Section 16 Planning Application for Proposed Minor Relaxation of Plot Ratio Restriction for Permitted Flat Use (Proposed Amendments to an Approved Scheme with Minor Relaxation of Plot Ratio Restriction under Application No. A/H6/91) at 4, 4A, 4B and 4C Tai Hang Road, Hong Kong (Application No. A/H6/97)

Responses to Departmental Comments

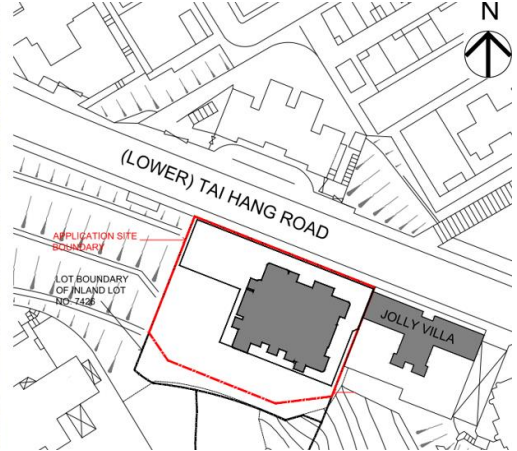
Departmental Comments	Responses to Comments
1.	Comments of Architectural Services Department	
1.1	The Applicant has not addressed our comment (b) directly. The Applicant should ensure that the proposed development will not diminish the light and air available to other existing building (i.e. Jolly Villa) in accordance with Building (Planning) Regulations 37.	Noted. The Applicant will ensure that the proposed development complies with Building (Planning) Regulation 37. In formulating the development scheme, the adjoining existing development (i.e. Jolly Villa) has been carefully taken into consideration. In particular, Jolly Villa has its windows facing north and south, while the proposed development is located on the west of Jolly Villa (see diagrams below). Therefore, there will be no issue of diminishing the light and air available.
